GOVERNMENT OF INDIA
MINISTRY OF ENVIRONMENT, FOREST & CLIMATE CHANGE
Central Zoo Authority

F. No. 22-2/2007-CZA(NS)/7890

Sub:- Layout Plan of Ambardi Wildlife Interpretation zone and design of proposed construction of Animal Upkeep Centre, Visitors' gate and emergency gate and design of proposed strengthening of toe wall of perimeter fence at Ambardi Wildlife Interpretation zone (Ambardi Safari Park)-Reg.

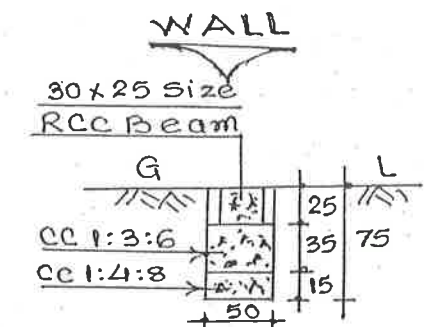
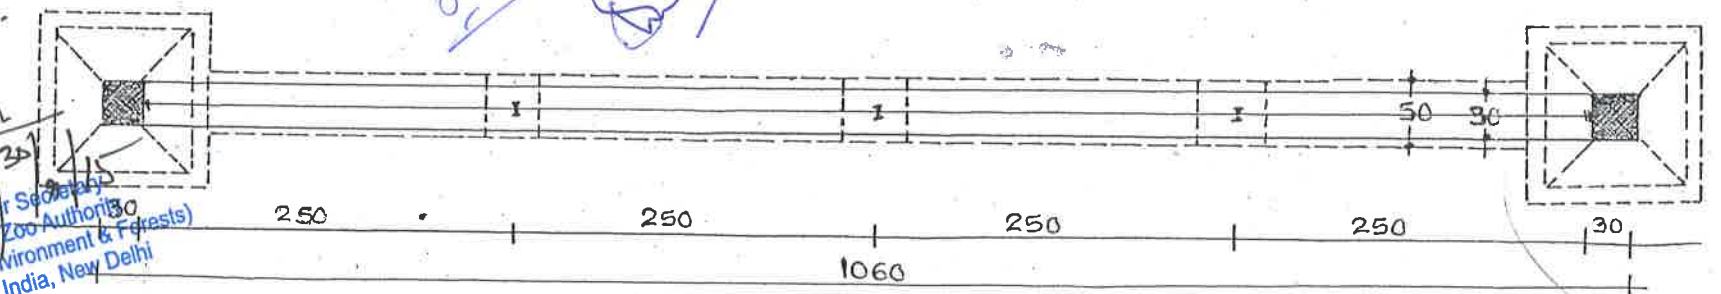
Members, on scrutiny of design of proposed strengthening of toe wall of perimeter fence, approved.
